Reference: Defect Reportable Under 10CFR21  
General Motors EMD Model 645E4 Diesels  
Used as Emergency Power Supplies  
Air Start Motor Defect

SUBJECT: Air Start motors for the EMD (General Motors) Model 645 Diesel Engines.

**FIG - 1**

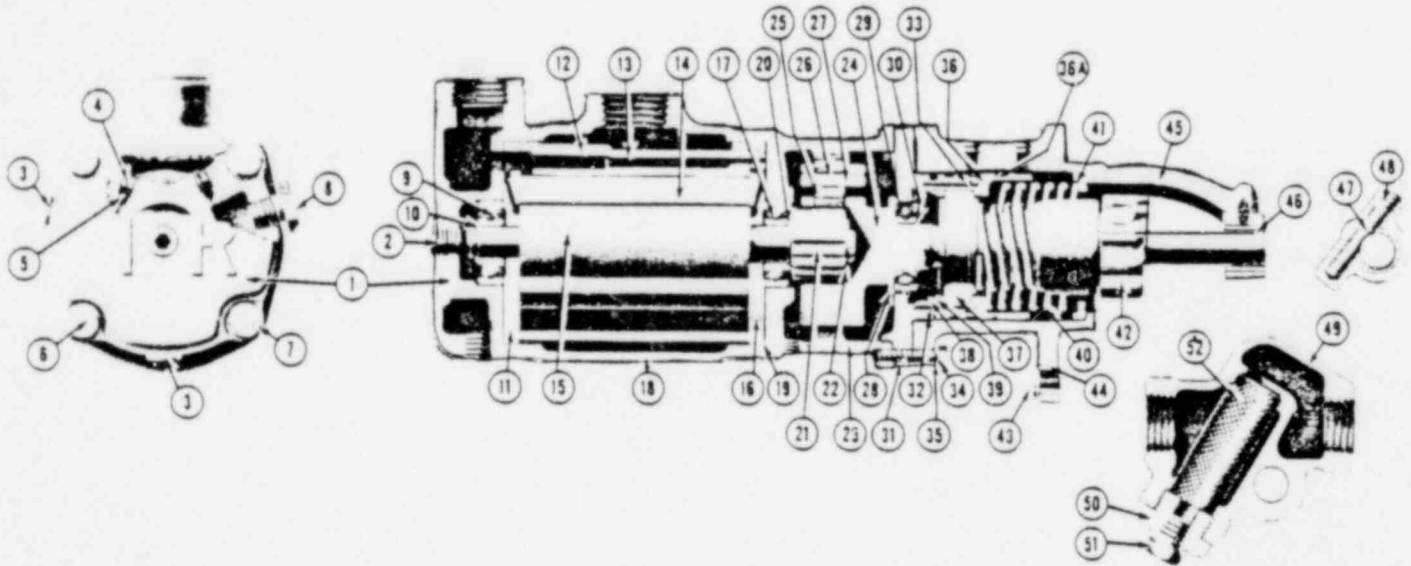
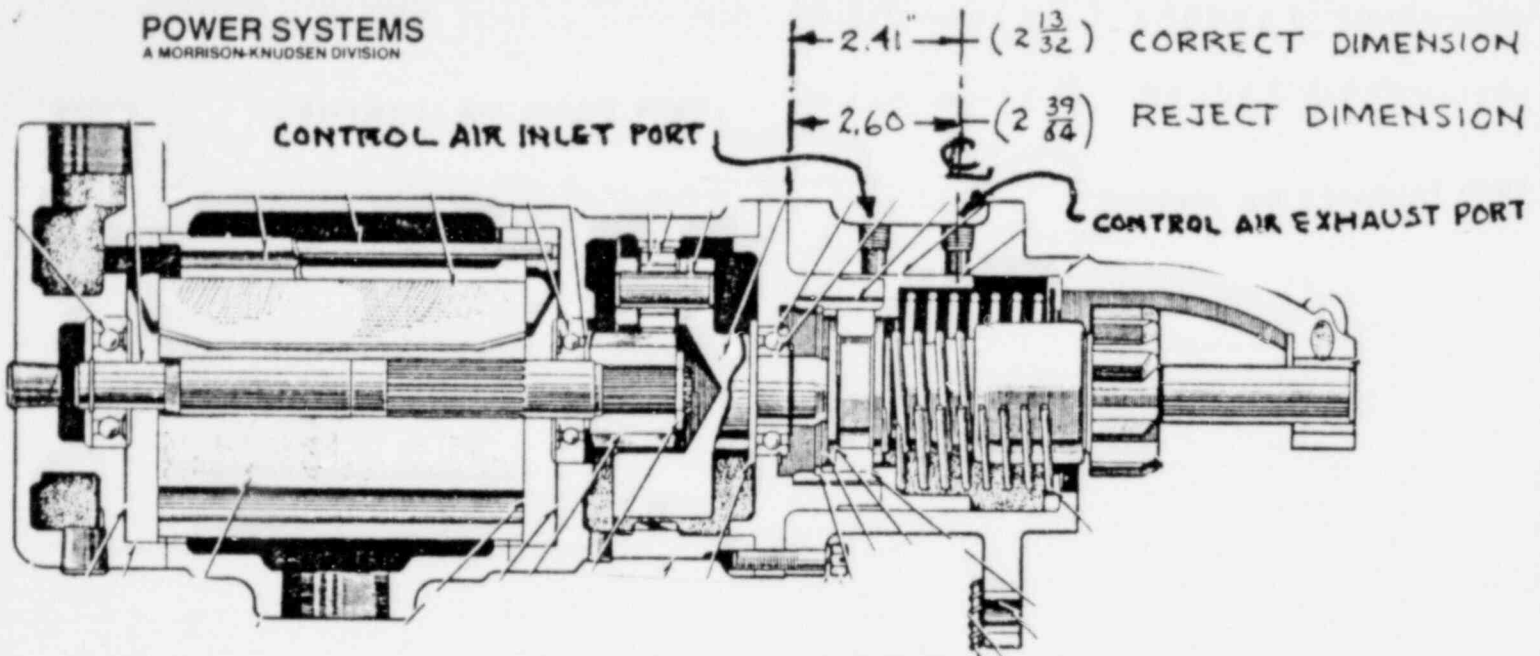
PROBLEM: Refer to Figure 1.

The location of the exhaust port of the control air from the engaging piston section changed such that it was moved approximately 1/8" further away from the control air intake port. There is a possibility that this dimensional change may retard the action of the starting motor engagement with the engine turning gear so that the engine cranking may be delayed a few seconds or may inhibit engine cranking. In start systems that have a recycle feature, this delay may cause the system to recycle and thereby affect the starting capability.

Motors with the reject dimension restrict the flow of air to the 2nd (upper) motor because Piston Seal #33 is now in the exhaust port area. When start motor #2 engages, it further restricts the flow of air for the same reason. Air exhausting from Motor #2 flows to a relay air valve which then is activated by the air from motor #2 to admit the main flow of air to the air start motor for cranking. This restriction of air flow may not prevent cranking but would retard the action time. Start systems with the recycle feature may be affected dependent upon the recycle time settings. In addition to the restriction to the air flow, the piston seal may be positioned such that a portion of the air flow will exhaust out to the start motor gear instead of flowing to the air relay valve. This could result in inadequate air pressure at the relay air valve causing that valve not to operate and, therefore, void the engine crank function.

All starting motors shipped from EMD from May 1981 to February 1982 are suspect and have to be inspected. Start motors with the reject dimension shall be replaced.

**FIG.- 2** EMD Supplied Starter Motor  
Air Circuit —

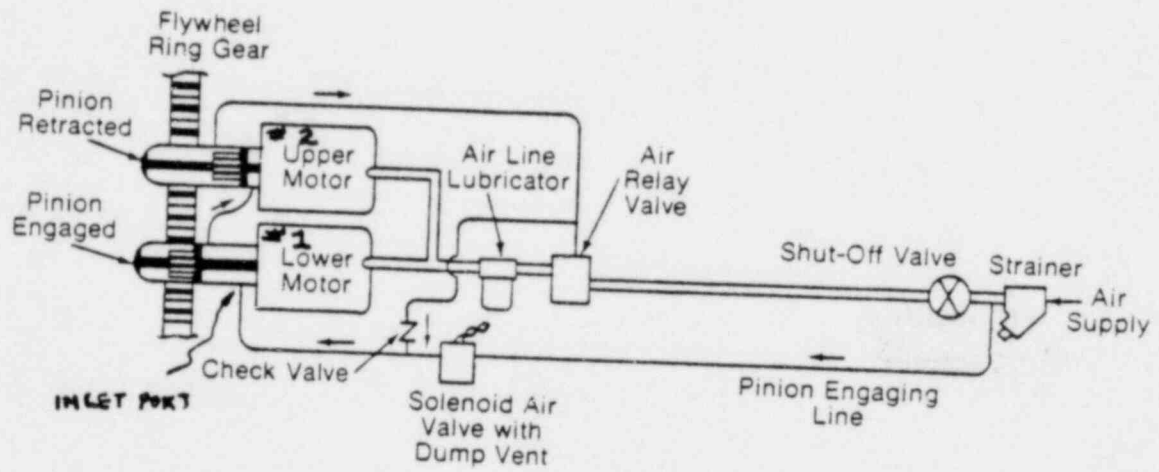
A control solenoid valve supplies air to the inlet connection and drives the engaging piston #36 forward to engage the Bendix starter drivegear with the engine turning gear. The first motor must engage before the second motor can engage.
